## DOCUMENT CHANGE REQUEST

DCR number	593	Changes required for:	General	Originator:	Jean-Laurent BOUTEAUX
Date:	2010/04/21	Date sent:	2010/04/21	Organisation:	CNES
Status:	IMPLEMENTED

Title:	Connectors Miniature Electrical Circular Triple-Start Self-Locking Coupling Scoop-Proof Hermetic
--------	--

Number:	3401/057	Issue:	2
---------	----------	--------	---

**FIGURE 2(b) – SPECIAL CONTACT ARRANGEMENTS – FRONT VIEW MALE INSERT (3)**

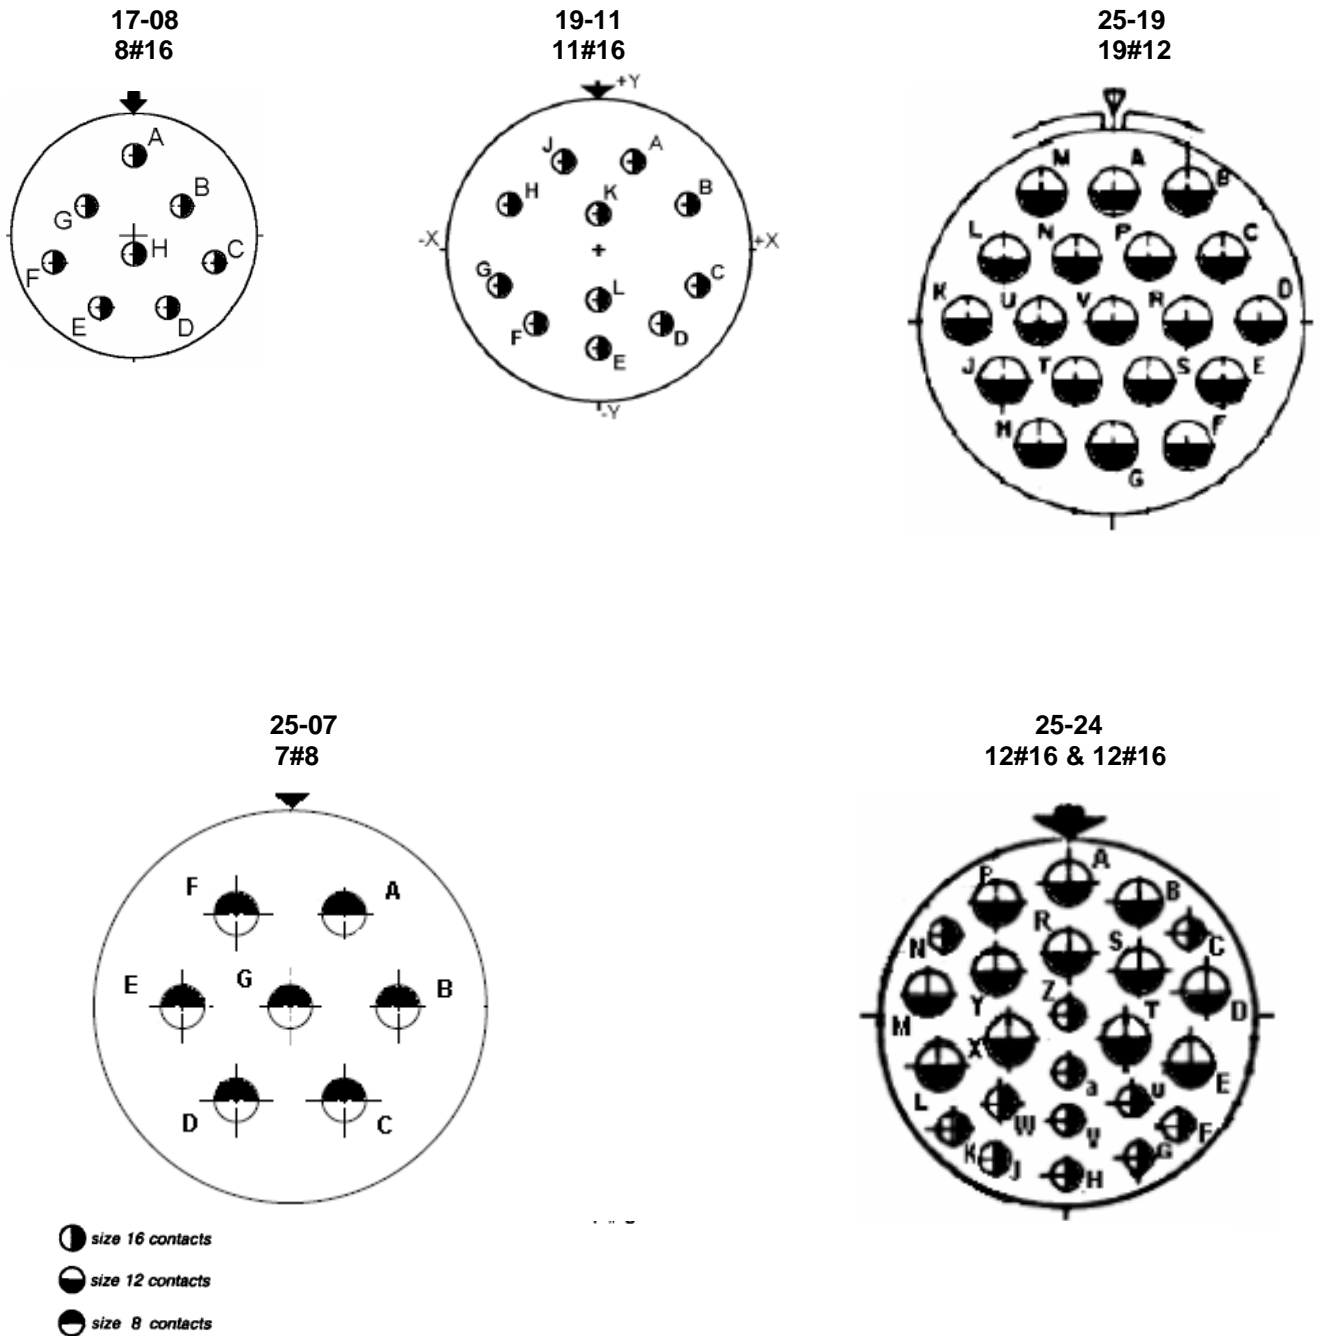
Page 13 "Special contact arrangements"  
Add 25-24 (12 #16 & 12 #12)  
Page 19 Â§ 4.5.4.3 Contact arrangements  
Add 25-24 Service Rating II

The attachment (page 13) to be corrected:

25-24 arrangement

It should read:

25-24

12 #12 & 12 #16
